Master Deed Amendments

**FIRST AMENDMENT TO THE
MASTER DEED OF
HARTLAND ESTATES**

REPLAT NUMBER 2 OF EXHIBIT "B" TO THE MASTER DEED OF
HARTLAND ESTATES
A LIVINGSTON COUNTY CONDOMINIUM SUBDIVISION
BEING PART OF THE SOUTHEAST 1/4 OF SECTION 19,
T3N. R6E. HARTLAND TOWNSHIP, LIVINGSTON COUNTY, MICHIGAN
LIVINGSTON COUNTY CONDOMINIUM SUBDIVISION PLAN NUMBER 138
SURVEY & UTILITY PLAN

T3N, ROE, HARTLAND TOWNSHIP, LIVINGSTON COUNTY, MICHIGAN
LIVINGSTON COUNTY CONDOKINIUM SUBDIVISION PLAN NUMBER 136
AMENDMENT No. 2 TO RRPLAT No. 4 OF EXHIBIT "B" TO THE MASTER DEED OF

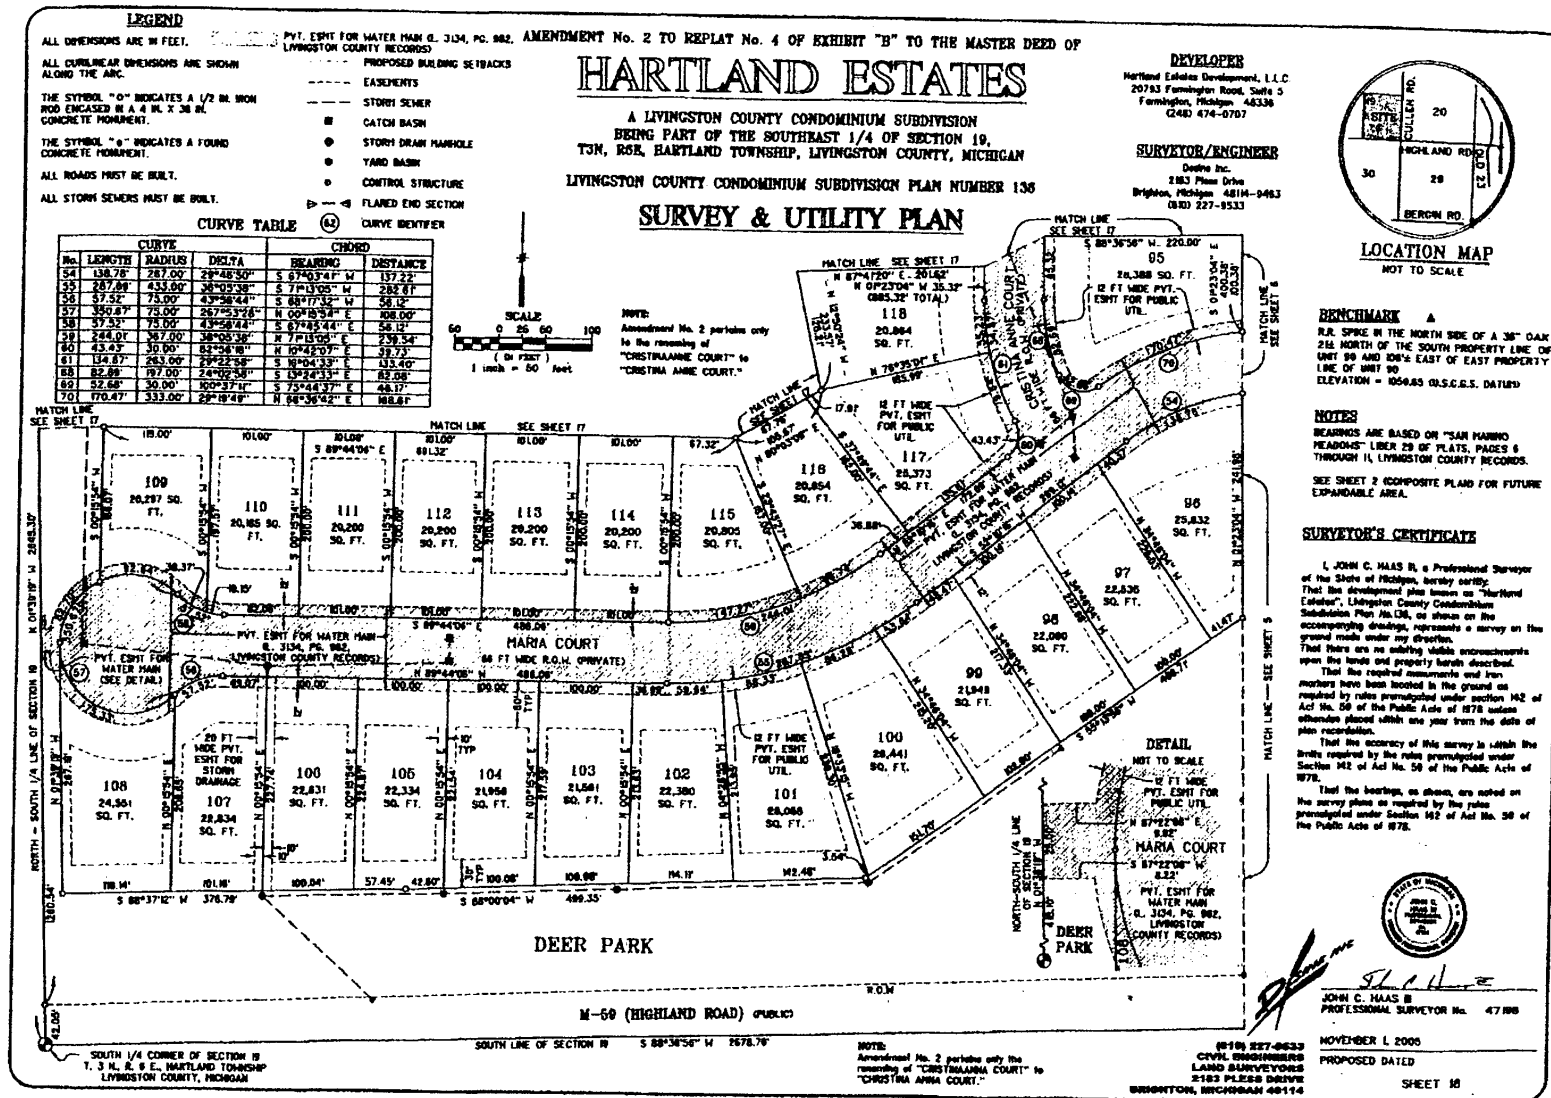
Amendment No. 2 pertains only to the
removing of "CRISTINAANNE COURT" to
"CRISTINA ANNE COURT"
